CITY OF ALBUQUERQUE

**RE: Primrose School
Grading Plan
Engineer's Stamp Date: 11/01/2018
Hydrology File: C13D029**

**RE: PRIMROSE SCHOOL
GRADING PLAN
ENGINEER'S STAMP DATE: 08/29/2018
HYDROLOGY FILE: C13D029**

**DRAINAGE REPORT
FOR**

48' F-F STREET SECTION W/ 8" CURB

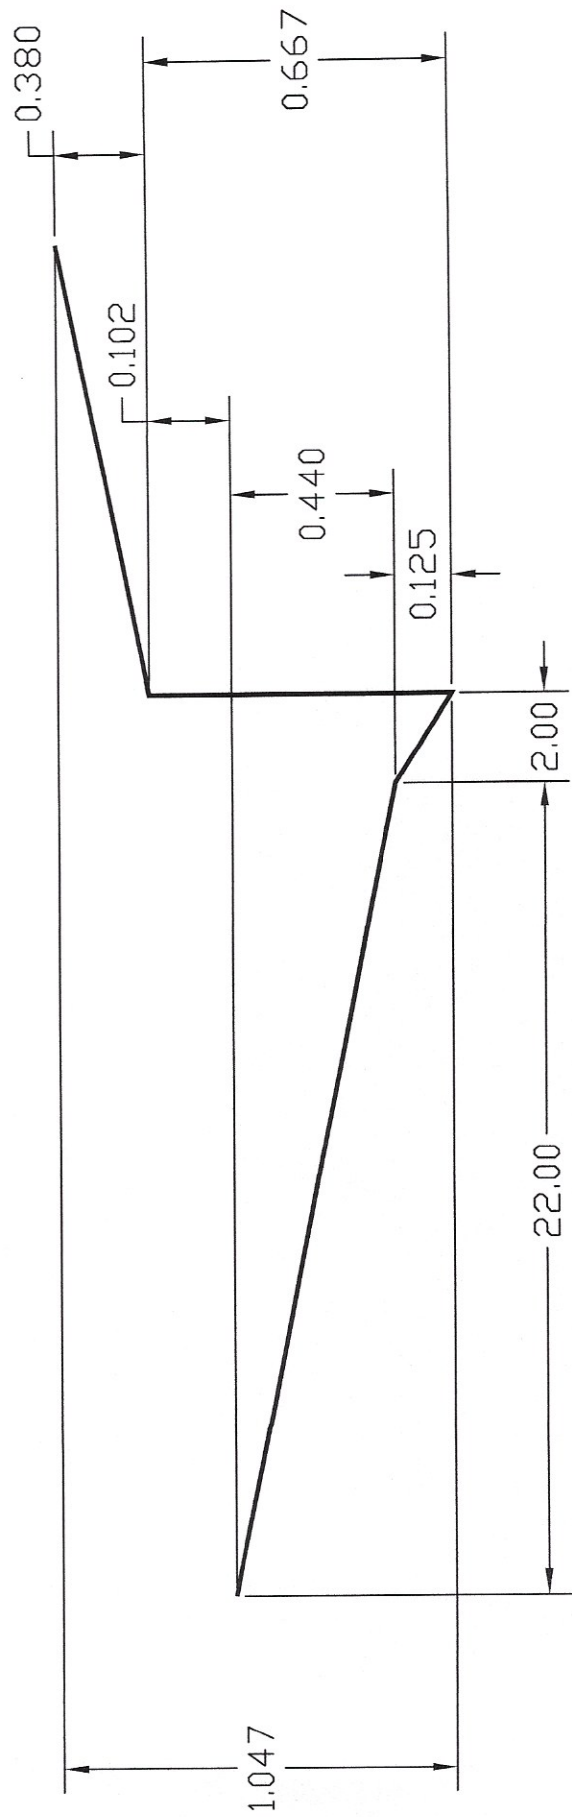
2. Paradise Blvd capacity calculations are not accurate.
 - a. Basin B has free discharge.

- c. The discussion of inlet interception on page 6 is not support by inlet calculations using the criteria in the DPM where first the actual flow depth is calculated and then the interception is figured using the inlet nomographs in the DPM. Inlet interception does not need to be discussed since the limiting factor is the 18" pipe capacity at section E-E instead of the actual inlet interception.

Basin B does not have free discharge. The Grading Plans for that development has a number of detention ponds and only 6.66 cfs is released from this basin to the street.
 - b. Inlet interception in basins A, B, C, D, E, F, H, and K as discussed on Page 6 is irrelevant since the 18" pipe at section E-E on the G&D Plan only has capacity for 7.45 cfs. Even though the inlets upstream may intercept more flow it can't get thru the pipe so it must be conveyed on the surface.

Actually the inlet interception is relevant for the inlets at the intersection of Eagle Ranch and Paradise. As stated in the Mark Goodwin drainage report for the Westpark Apartments (C13-D3) that storm sewer intercepts 26.80 cfs

which is just over the amount I've calculated that drains to the inlets of 26.46 cfs. That flow does enter the storm sewer at the intersection. You are correct in that the 18" RCP only has the capacity for 7.45 cfs as we have confirmed. As also stated in the Westpark Apartments Report the western most inlet for the AG Spanos project will overflow and discharge 19.26 cfs into Paradise Boulevard at that location. Our street capacity calculations now account for this overflow discharge.

We concur with this assessment.

PRIMROSE SCHOOL OF NW ALBUQUERQUE		DRAWN BY pm
	CONCEPTUAL GRADING PLAN-TRAIL DETAIL		DATE 11-1-18
	 5571 MIDWAY PARK PL. NE ALBUQUERQUE, NEW MEXICO 87109 (505) 858-3100 www.tierrawestllc.com		SHEET # 3-A
			JOB # 2017092

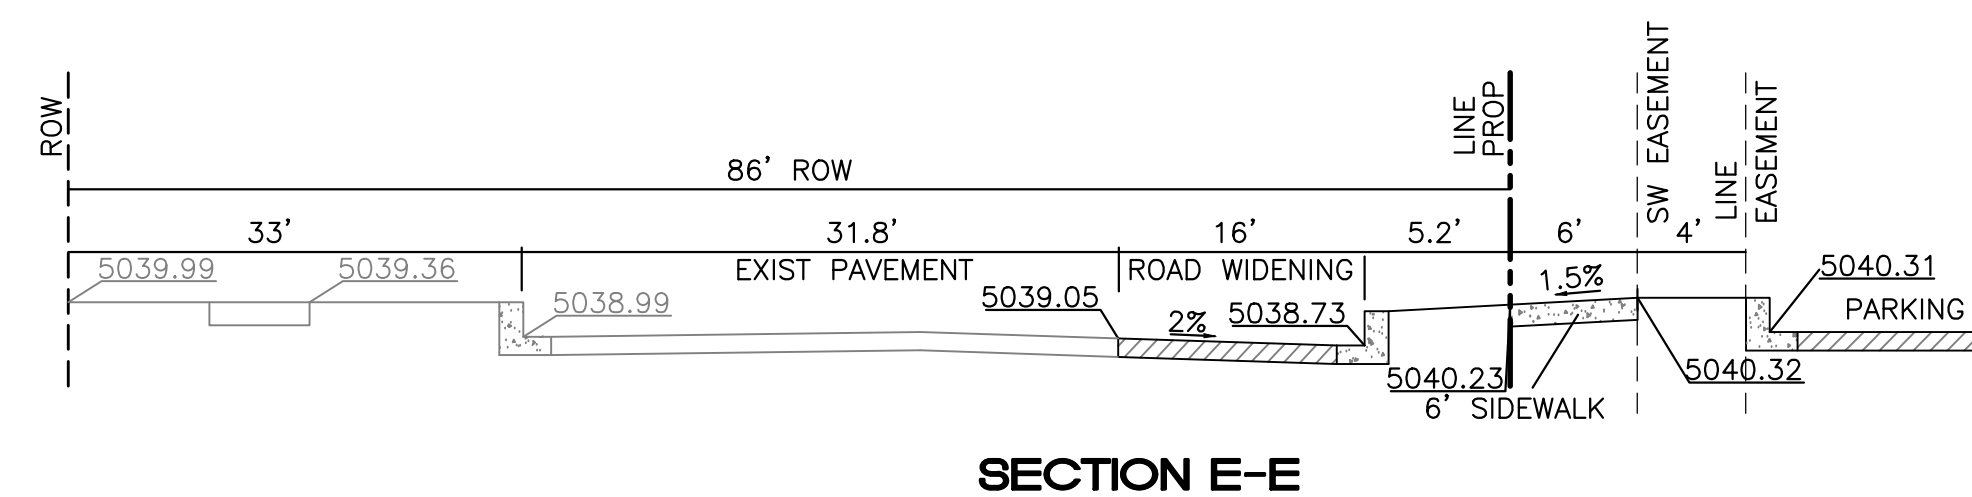
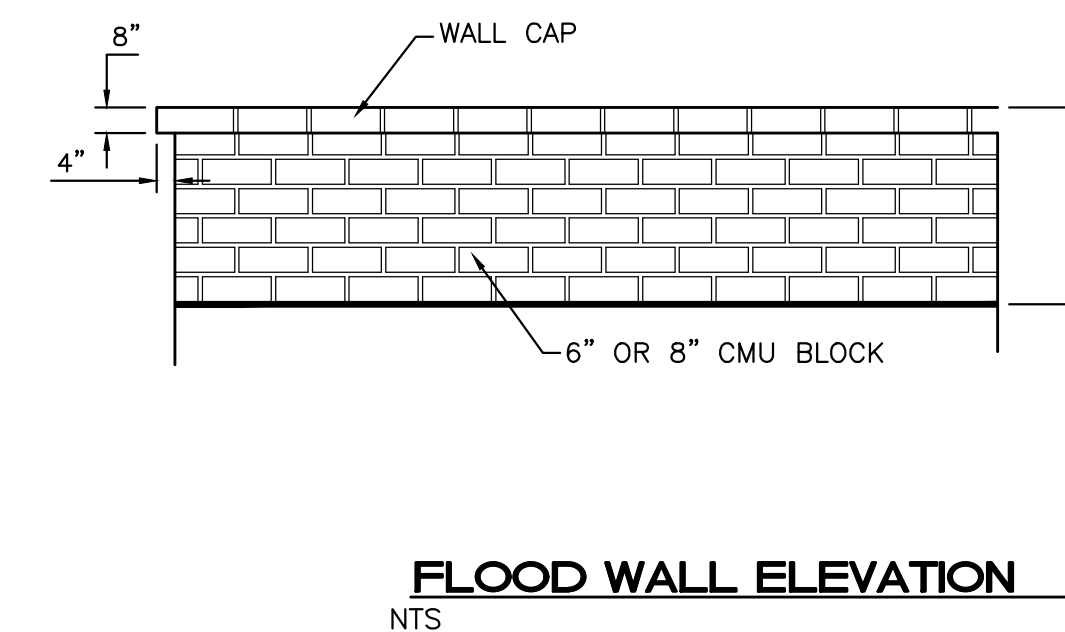
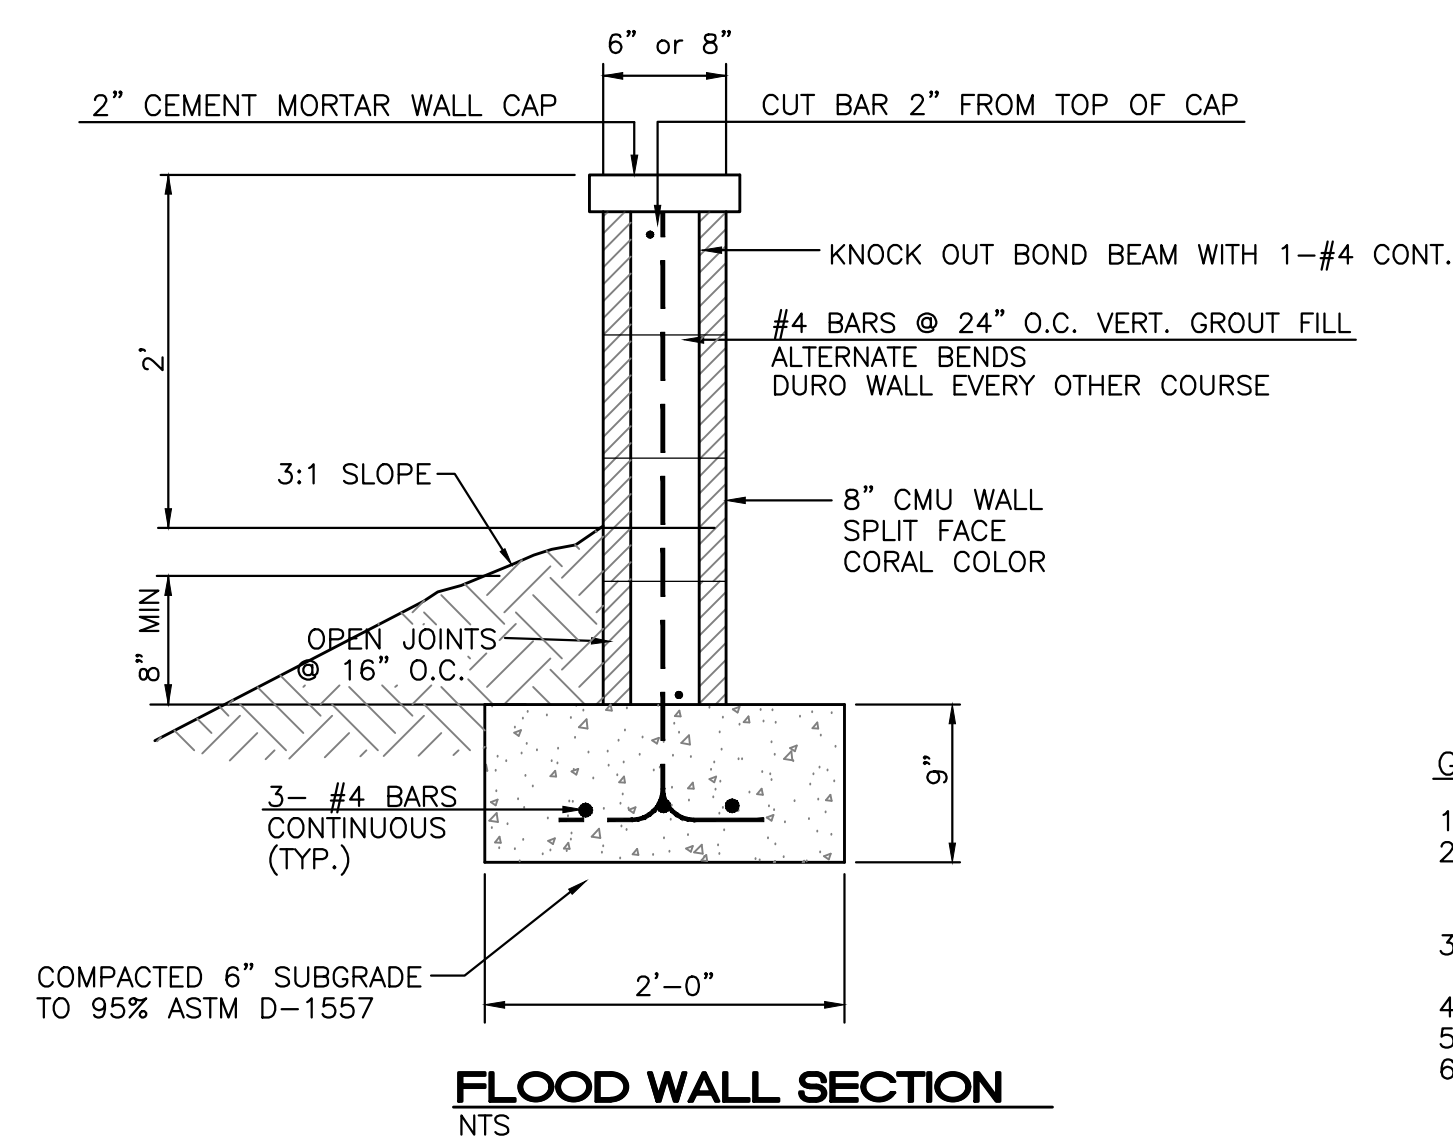
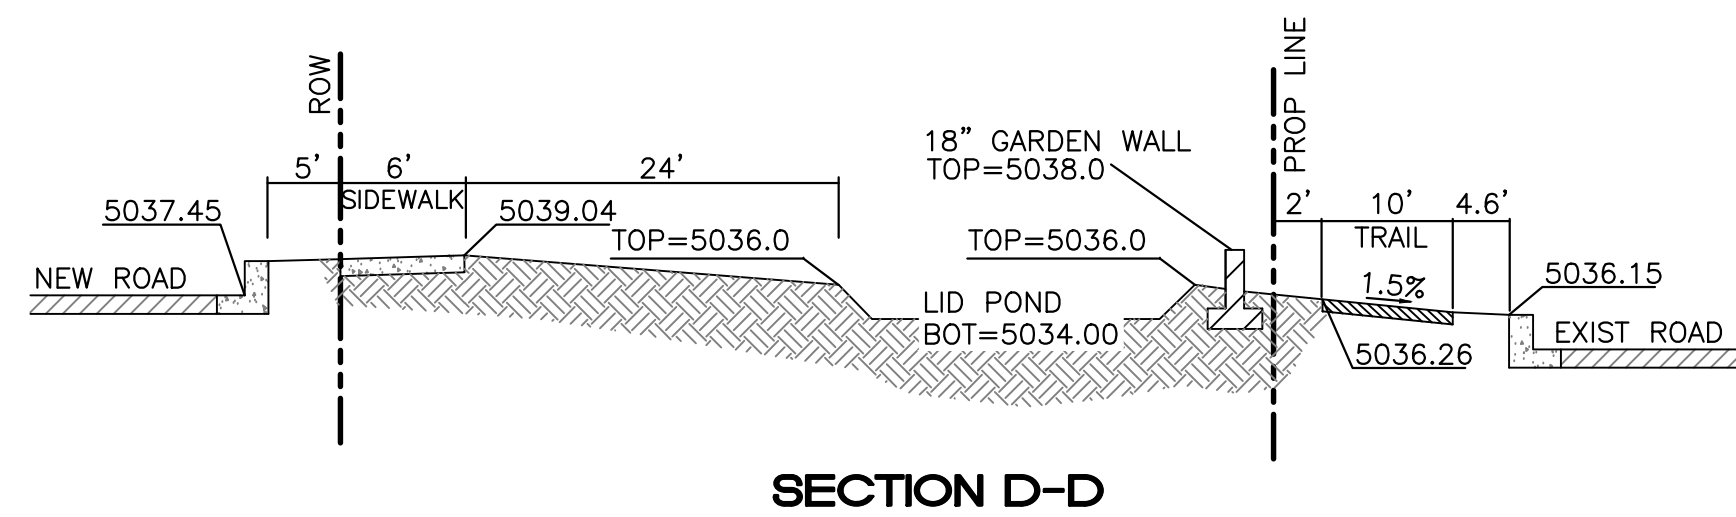
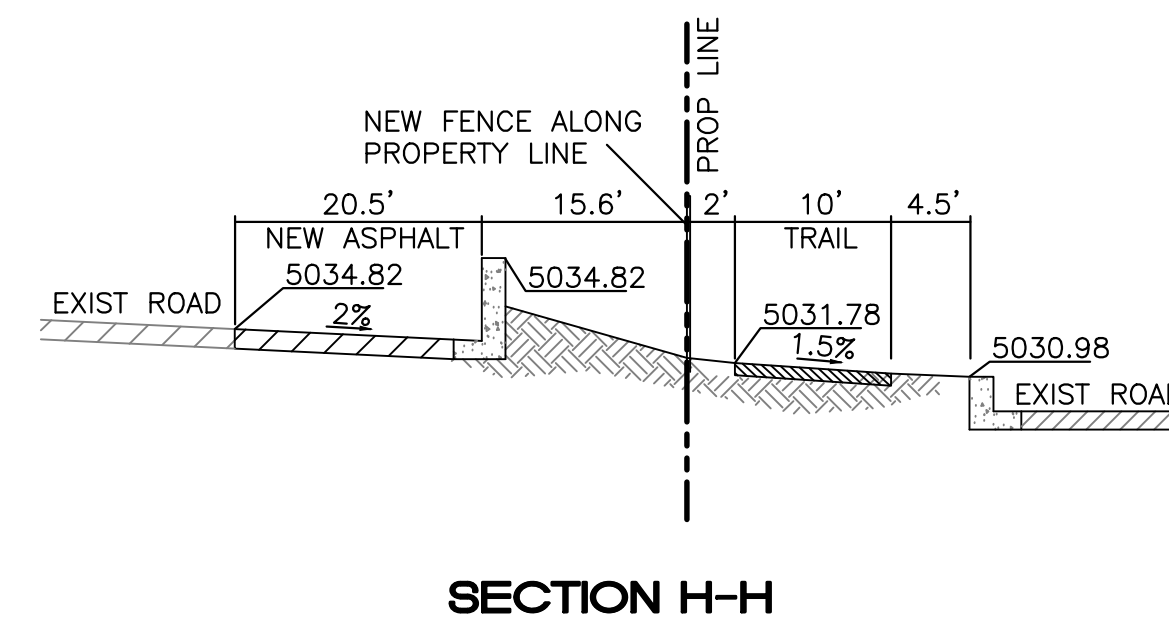
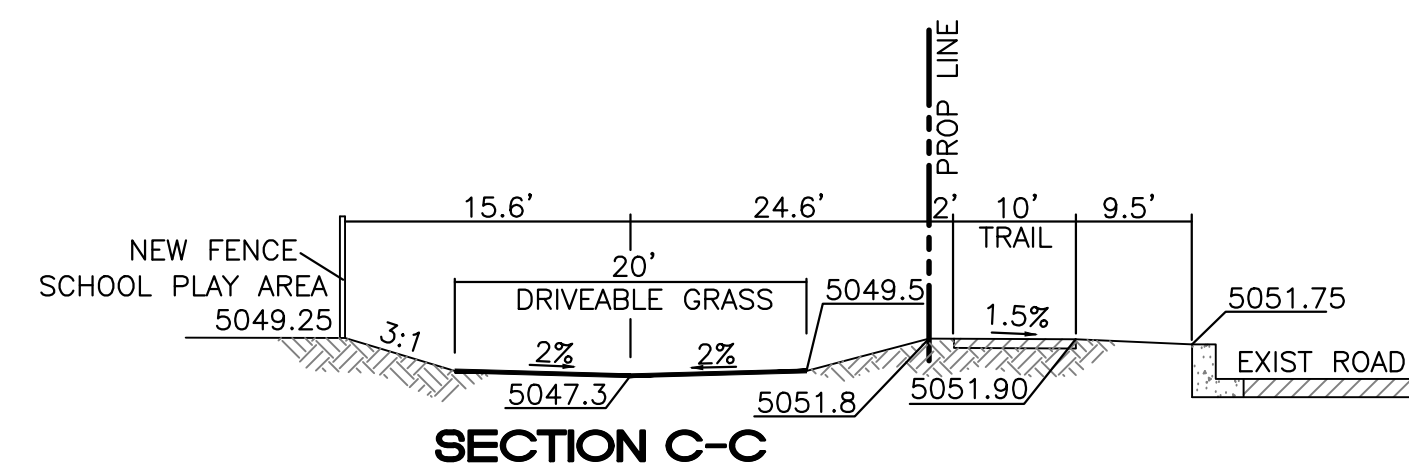
1. Add short piece of curb and gutter across the south edge of the parking lot to prevent drainage from entering the Paseo Del Norte right of way. The shape of the 5047 contour indicates that the curb is there, but the lines for the curb need to be added to the plans.

2. The work order plans need to show the back of sidewalk 1.12' above the flow line of the C&G along Paradise Blvd. with non-erosive landscape material between curb and sidewalk.
